Access Compliance Report Public Rights-of-Way (Curb Ramps)

Main Street: WESTON_PL Cross Street: MATRYCE_WAY Location: NW

ADA ID: RPAT211001142337 Ramp Type: Type 1 - Perpendicular Diagonal Initial Pass/Fail: Pass Overall Compliance: No Severity Score: 0

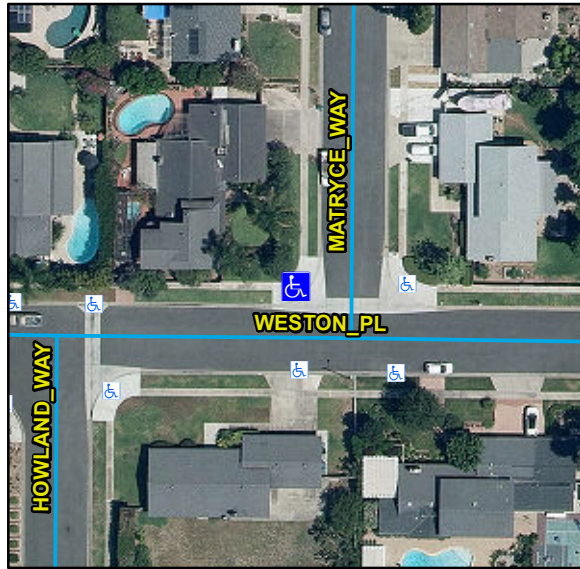
Compliance	Description	Data	Compliance	Description	Data
N/A	Ramp Length (in)	68	N/A	Flare Type LT	
Yes	Ramp Width (in)	49			Sloped
Yes	Ramp Run Slope (%)	7.9	N/A	Flare Slope LT (%)	2.7
Yes	Ramp Cross Slope (%)	0.8	N/A	Flare Traversable LT	No
N/A	Landing Present	Yes	N/A	Flare Type RT	
N/A	Landing Length (in)	49			Sloped
Yes	Landing Width (in)	48	N/A	Flare Slope RT (%)	11
Yes	Landing Run Slope (%)	0.3	N/A	Flare Traversable RT	No
Yes	Landing Cross Slope (%)	1.1	Yes	DWS Provided	Yes
N/A	Landing Movement Obstructed?	No	Yes	DWS Contrast	Yes
	Landing Movement Type	N/A	Yes	DWS Length (in)	36
N/A	Landing Shared	No	Yes	DWS Full Width	Yes
N/A	Clear Space	Yes	Yes	DWS Offset Left (in)	0
N/A	Clear Space To Crosswalk (in)	48	Yes	DWS Offset Right (in)	N/A
N/A	Marked Crosswalk 1	No	N/A	Marked Crosswalk 2	No
	Crossing 1 Direction	S		Crossing 2 Direction	E
	Marked Crosswalk 1 Width (in)	N/A		Marked Crosswalk 2 Width (in)	N/A

N/A	Ramp Inside Crosswalk 1	N/A	Yes	Ramp Inside Crosswalk 2	N/A
	Crossing 1 Slope (%)	4.8		Crossing 2 Slope (%)	2.7
	Crossing 1 Cross Slope (%)	0		Crossing 2 Cross Slope (%)	2.1
Yes	Gutter Ponding	No	No	Curb Slope	9
Yes	Gutter Lip Height (in)	0		Road Run Slope (%)	1.1
Yes	Gutter Run Slope (%)	2.6		Road Cross Slope (%)	0.5
No	Gutter Cross Slope (%)	2.4			
Yes	Overall Surface Condition: Acceptable		Yes	Perp Joint Present	Yes
	Cross Gutter Present?	Yes		Spandrel Present?	Yes
	Replace Cross Gutter?	No		Replace Spandrel?	No

Remove & Replace Curb Slope. Remove & Replace Gutter.

R304.2.2, R304.5.3, STD 1115
